**Economic Commission for Europe****Inland Transport Committee****Working Party on the Transport of Perishable Foodstuffs****Seventieth session**

**Proposal of amendments to the ATP: Pending proposals****ATP Handbook****Marking of multi-temperature equipment****Transmitted by the Government of Portugal***Summary*

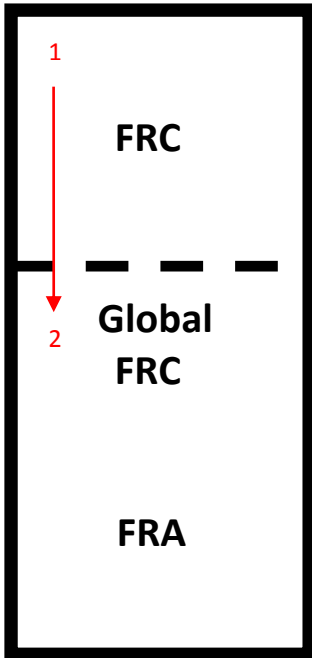
8. In Annex 1, Appendix 3, section B, paragraph 2, after the existing plate model, insert a new model for multi-temperature equipment as follows:

**ATP** APPROVED FOR TRANSPORT  
OF PERISHABLE FOODSTUFFS  
APPROVAL NUMBER: [GB-LR-456789]\*  
EQUIPMENT NUMBER: [A1234567]

ATP MARK: **FRC(C-B-A)\***

Distinguishing marks

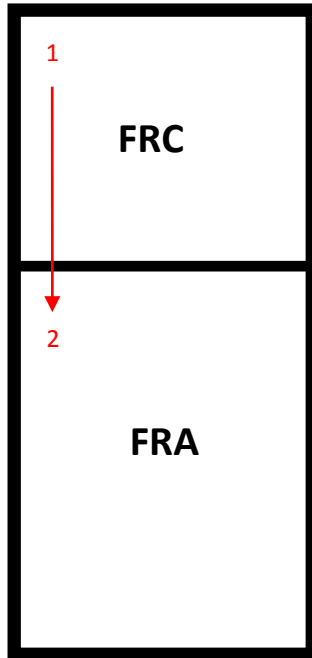
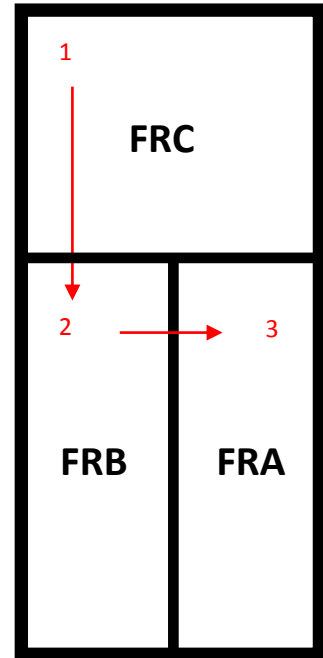
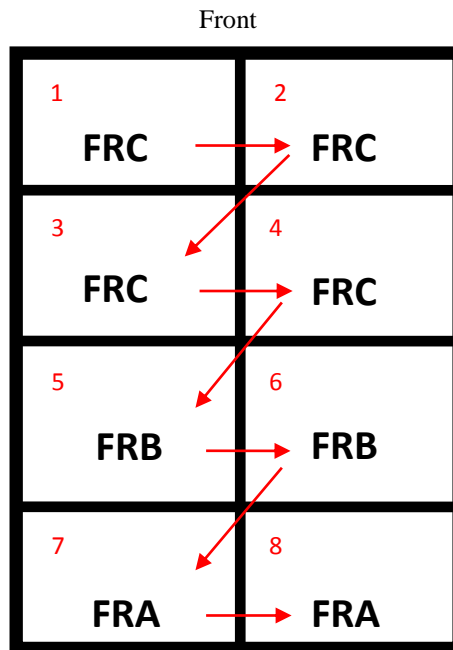
9. In Annex1, Appendix 4 after the new paragraph 3, insert the following:

"Examples of distinguishing marks for multi-temperature equipment:

2 and 3 compartments:

Removable bulkhead

Fixed non-removable wall

Fixed non-removable wall
